AMENDMENTS TO THE DRAWINGS

Application No. Not Yet Assigned
Amendment dated February 10, 2006
First Preliminary Amendment

Docket No.: SON-3074

FIG. 3

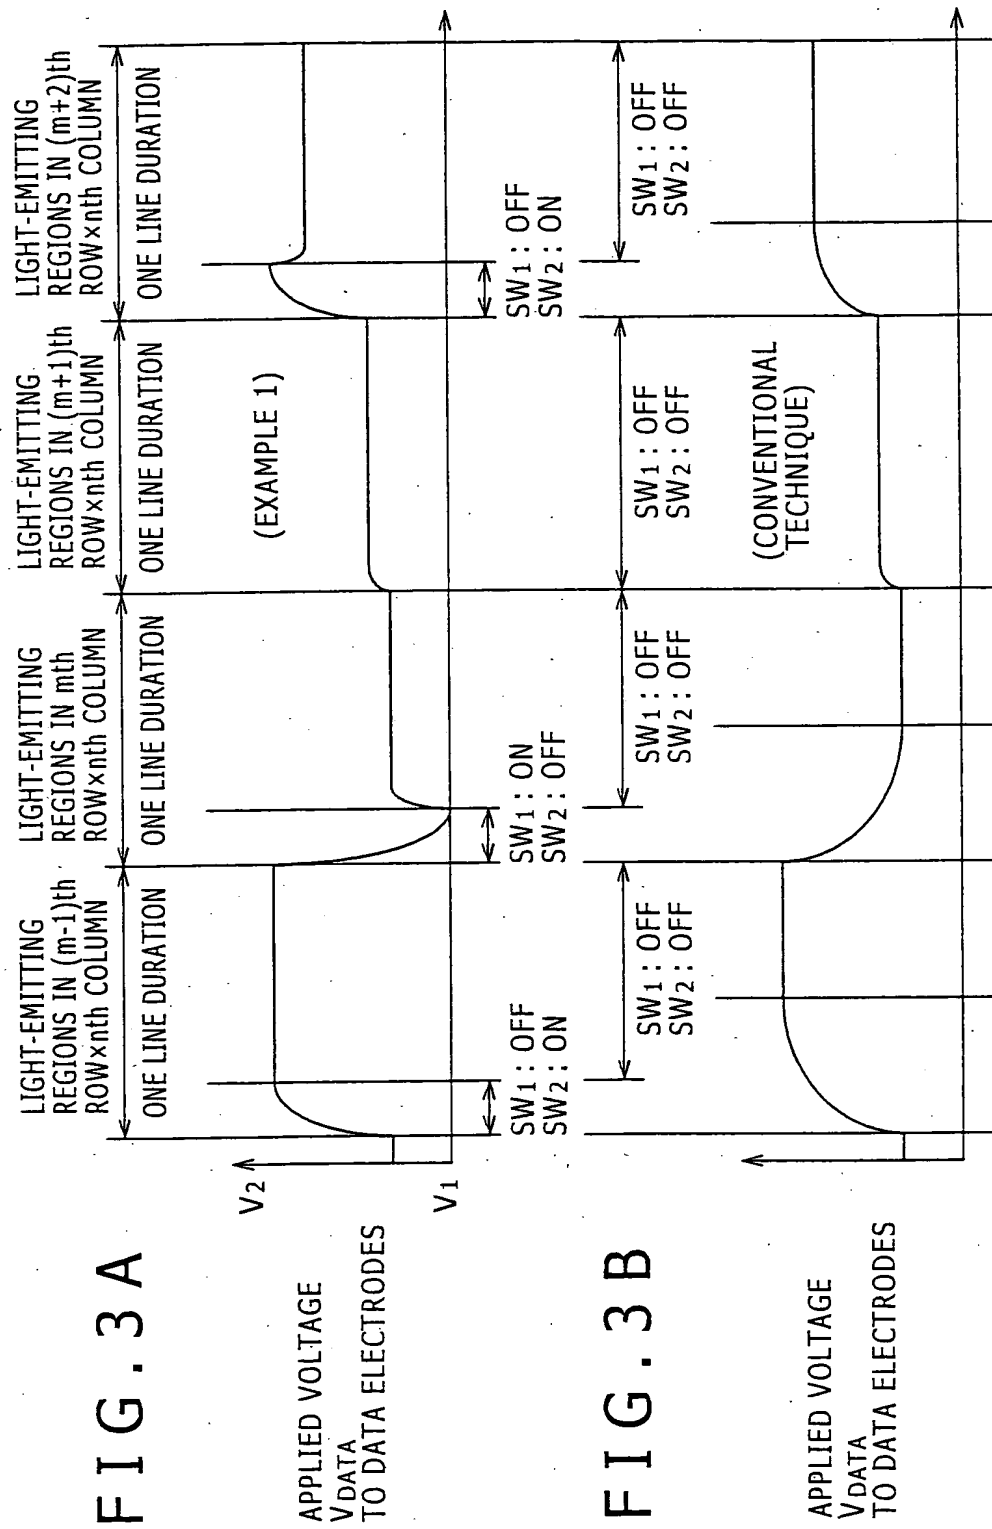
The attached sheet(s) of drawings includes change to FIG. 3A and 3B.

This Preliminary Amendment is requested prior to the initial examination of the above-identified patent application to correct FIGS. 3A and 3B.
